# **Evaluation of Delta Wetlands Proposed Fish Screens, Siphons and Pumping Stations**

Prepared for  
**Department of Water Resources'  
Consulting Panel on December 12, 2001**

Task Order Number IDS-1001-1747-001 (Agreement Number 46000001747)

December 2001

Figure 5  
Siphon Plan View  
May 10, 2001

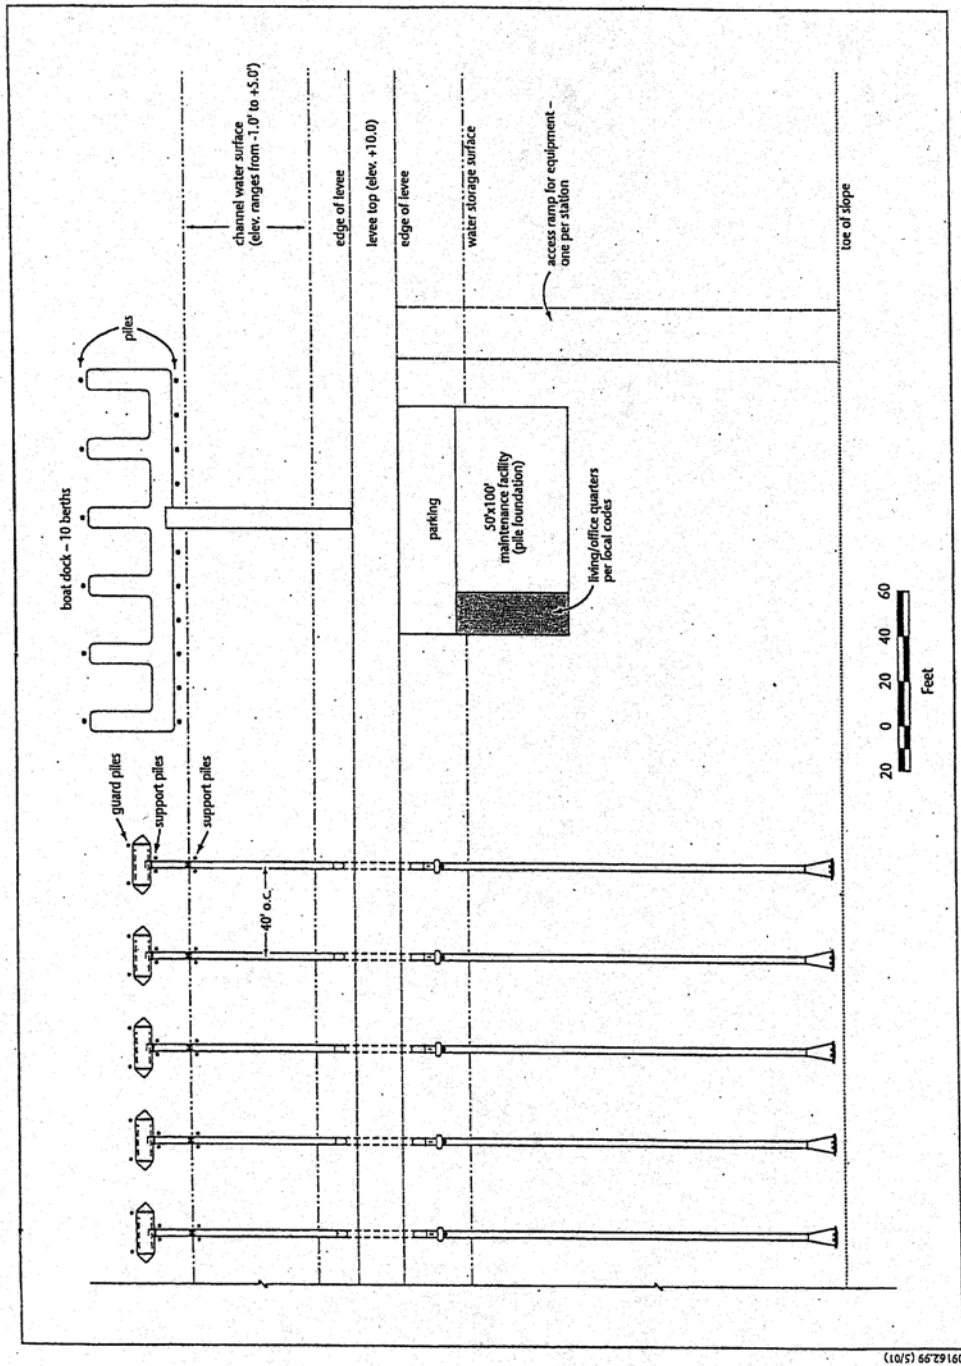
The plan view of the siphons is shown on Figure 5. Figure 6 shows an intake siphon unit in plan and elevation. The fish screen design is shown on Figure 7.

Settlement: The siphons are shown to be supported on the slough side of the levees by piles. The siphons on the crest and reservoir side are shown to be founded directly on the levee embankment. Additional fill will be placed on the crest and reservoir side of the levee embankments to raise them to the design crest elevation and configuration. Such additional fill will cause the levees to settle; such settlement would cause distress in the 36-inch diameter siphon pipe. Pipe bends at the levee crest would become overstressed and are subject to breaks. The effects of settlement on the siphons can be mitigated by providing flexible connections at critical points, such as at the crest of the levee. The design of flexible connection would need to be based on the anticipated settlement. The siphon pipes would need to be periodically returned to their original elevations if the settlement approaches the limits of the movement that could be accommodated by the flexible connections. The use of ball-joint ductile pipe, while expensive, should be considered for this application.

Levee Stability: The levees are subject to slope failure, especially during times of flooding. Slope failure would disrupt and damage the siphons. Mitigation of slope failures would require site specific assessments of slope stability at the siphon locations, and flattening of levee slopes, or use of toe drains, where there is a need to improve slope stability to meet criteria.

Figure 6  
Intake Siphon Unit  
May 10, 2001

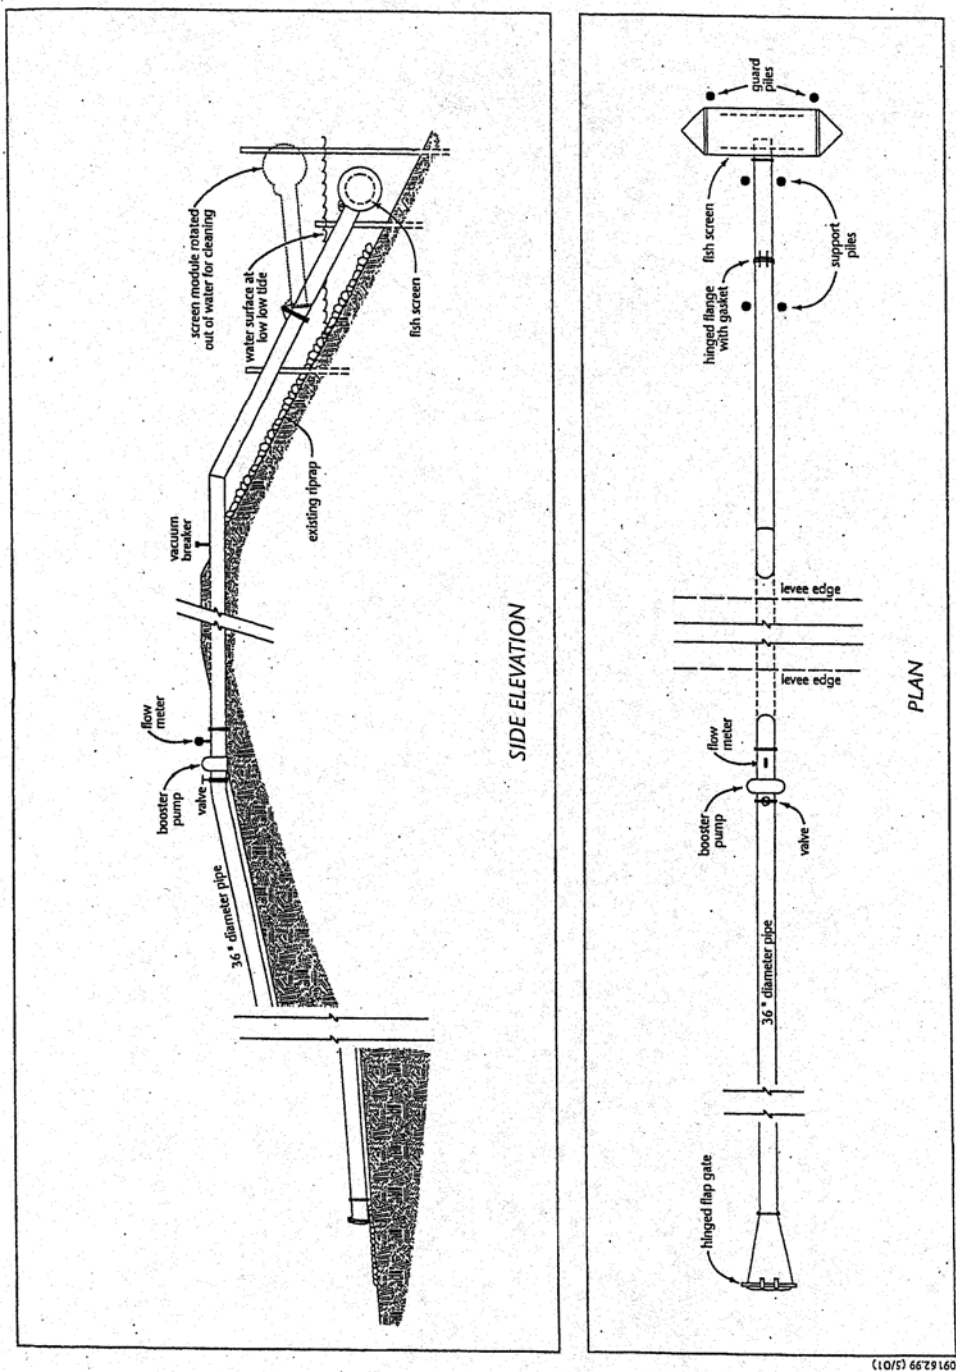
Pipe Stress from Excessive Velocity and Thrust: Pipe velocities may exceed 12 fps at design flows of up to 86 cfs. Pipe velocities are typically designed to be much lower than this (rule of thumb is 10 fps or lower), for pipelines of this diameter, generally due to excessive head losses in the pipes. Interior wear in the pipe can accelerate with the increase abrasive forces. The proposed pipe bends will be subject to thrust loads due to the change in momentum. No thrust blocks or restrained joint systems are shown in these areas.

**Figure 7**  
**Fish Screen Design**  
 May 10, 2001

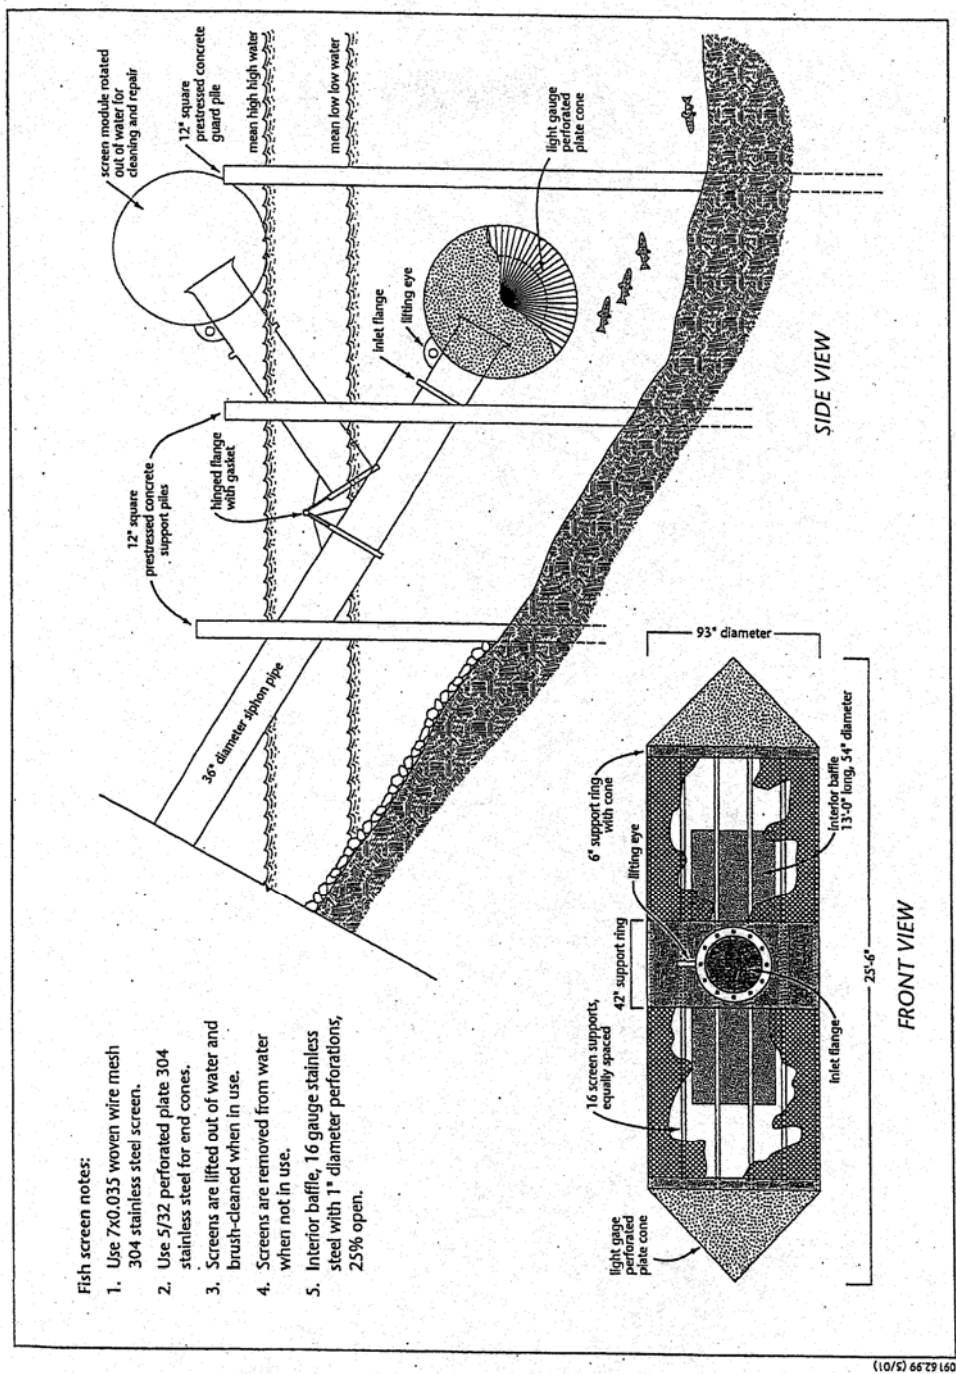
Fish Screen Structure: Fish screen units are subject to a variety of loading conditions that include rising and falling of tides, wave action, head loss through the fish screens, and operational loads when the screens are lifted from the slough for cleaning. The fish screens are shown to be 25.5 feet long and 7.75 feet in diameter. The conceptual design shown on Figure 7 indicates that the fish screens may not be structurally sound. The structural members consist of 16 screen supports attached to a 3.5 foot long support ring that is attached to the siphon pipe. Details such as the dimensions of the screen supports and support ring are not shown. Conservatively, these supports should be designed for full hydrostatic head, all dead loads from the screen, and also for lateral and wave loads.

Hydrostatic head can be the greatest of these forces since they can cause collapse upon debris clogging, a common mode of failure. In the past several years, several cylindrical screens have imploded (i.e. collapsed due to excessive head) on the Sacramento River (Plates 2 and 8). If full head is not designed into the internal screen supports, a “blow-out” plug can be installed to relieve excessive and damaging pressures. This plug would be designed to be sucked into the fish screens to reduce the head loss if the head were to exceed a pre-determined threshold level. Plugs would need to be monitored and replaced upon failure to prevent unscreened diversions. Once the design loads have been established, the screens would be designed to meet the loading demands.

This screen type is similar to those indicated in Section 3.1. A better screen mesh alternative is a structural panel of profile bar or wedge wire material. Wedge wire can be very rigid and withstand much higher loads than woven wire over backing bars. This material, however, can significantly add to the overall screen weight (and add to facility loads).

Wave action can cause cyclic loading of the screens and siphons and cause additional stresses, especially to the hinge points. Hinges have been utilized on pipes supporting screens on both DWR’s Sherman Island fish screens, and a previous screen on Bacon Island (Plate 1). The screen hinges have failed on both installations (Hayes and Whitlock personal communication, 2001). One way to reduce lateral cyclic loading on the fish screens and siphons is to locate a receiving cradle fixture for the siphon pipe on the supporting cross member between the two piles shown on Figure 6. This feature has been a part of several larger fish screen designs, such as at DWR’s Horseshoe Bend site, and the Pelgar-Mutual fish screen on the Sacramento River. Unlike the proposed Delta Wetlands screens, both of those screens do not have hinged systems due to their excessive weight and are therefore not easily removable.

The screens are shown to be lifted when not in use. Retrievable capability is a desirable feature to increase the screen life and facilitate maintenance. A lifting eye is shown located immediately at the screens, but the hoist/lifting mechanism is not shown or described. It is assumed that the hoisting may be done by crane that is periodically mobilized to lift the screens. Alternatively, the screens may be lifted by a winch and lever arm or by an overhead crane located above the screens. The latter method would require a frame structure on piles above the screen and should be accessible by bridge from the levee crest. A winch and cable system attached to a lever arm could also be used, but the stresses from such a system would be significant and likely infeasible due to the loads on such a system. A screen system installed on Bacon Island in 1992 had such a system, but it failed structurally within two years (Plate 1).

To reduce the cyclic loading and vibration on a hinged system, the screens could be retrieved via a rail system as shown on Plate 5, or lifted vertically by a fixed hoist. For the latter, hydraulic cylinders could be used similar to what is used to hoist radial gates for spillways. The cylinders would be operated from a frame above the screens.

Figure 8  
Pump Station Plan View  
May 10, 2001

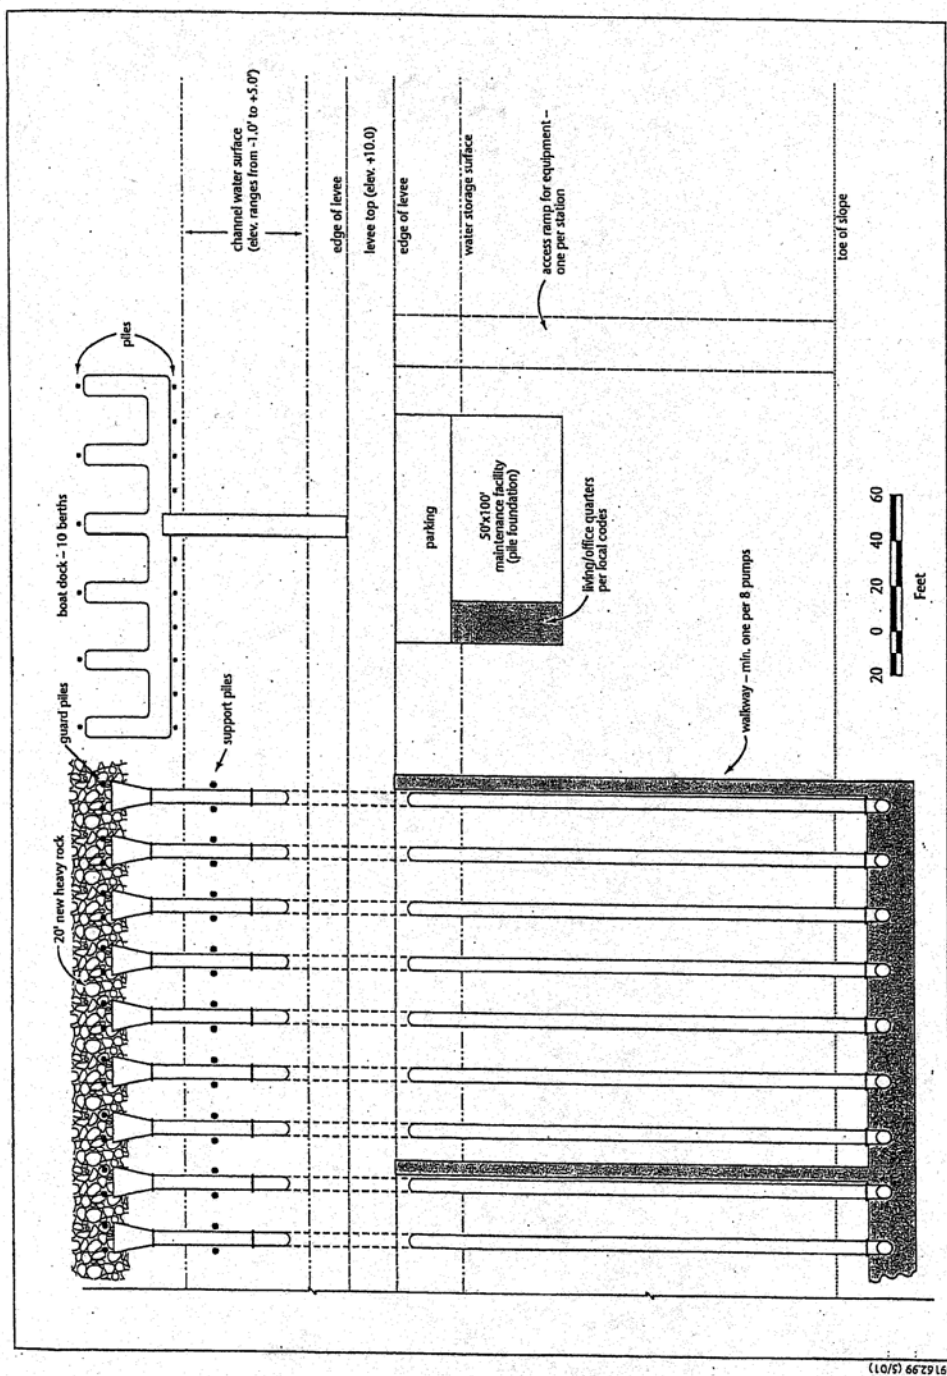
The plan view of the pump stations is shown on Figure 8. Figure 9 shows a discharge pump unit in plan and elevation.

Figure 9  
Discharge Pump Unit  
May 10, 2007

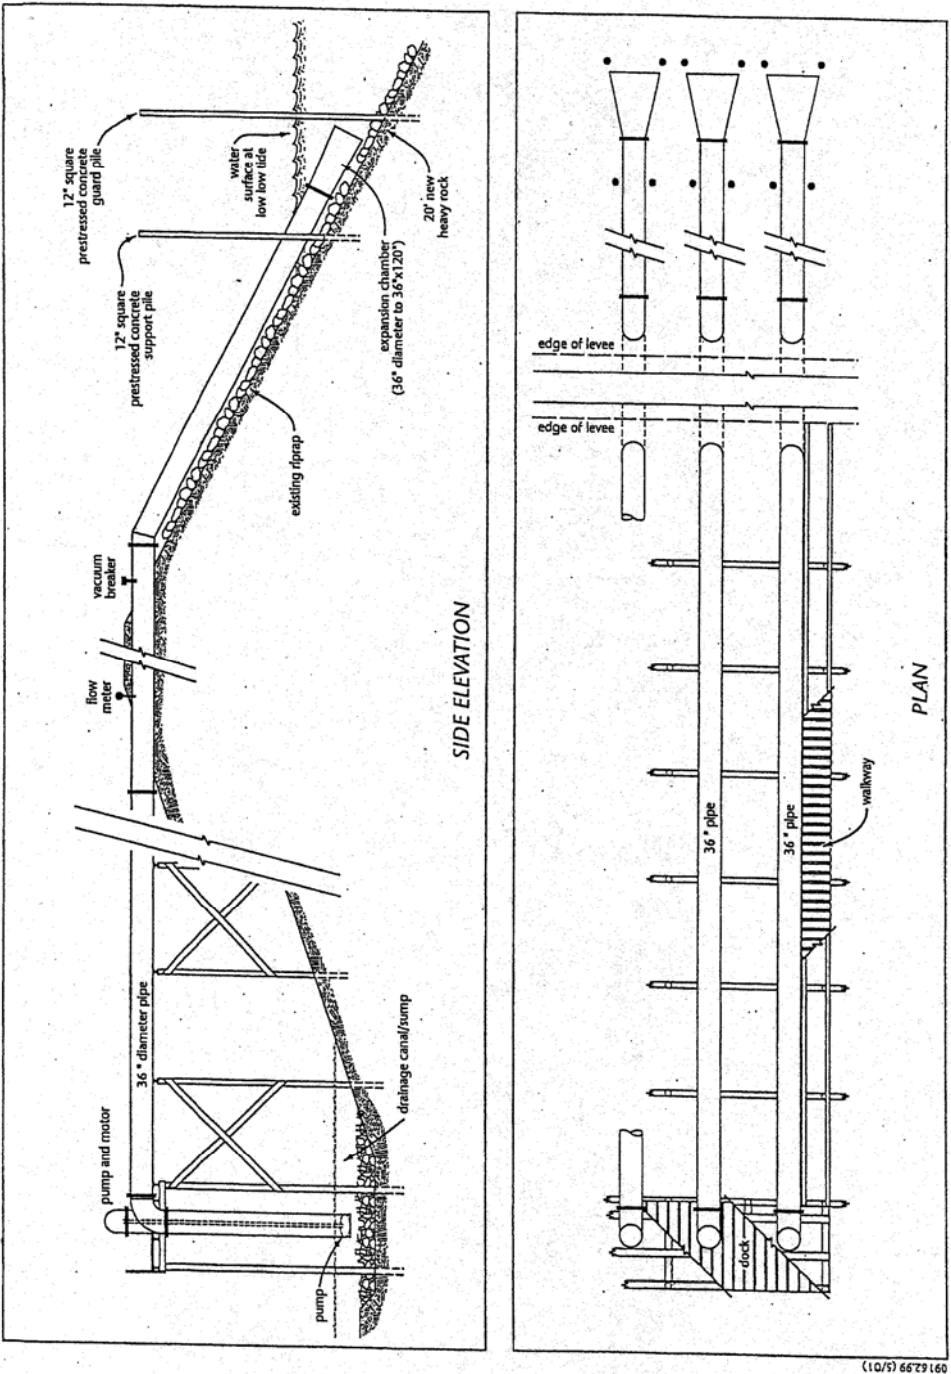
Settlement and Stability: The 36-inch diameter discharge pipe lines are shown to be supported on structural frames on the reservoir side and the pipes rest on the crest and slough side of the levee embankment. The settlement and stability issues for the siphons/fish screens discussed above, and their mitigation, also apply to the discharge pump systems. Settlement of the levee embankment can cause distress in the pipeline at the joints on both sides of the levee crest shown on Figure 9.

Erosion: The discharge end of the pipe shown on Figure 9 is located directly above the riprap on the slough side of the levees. For a discharge rate of about 94 cfs per pump, the discharge velocity would be about 13 fps through the 36-inch diameter pipe. The exit velocity would be reduced by the expansions shown on Figure 9. The riprap would have to be sized to be stable on the slough slopes due to the exit velocities from the discharge pipes and from wave action in the sloughs.
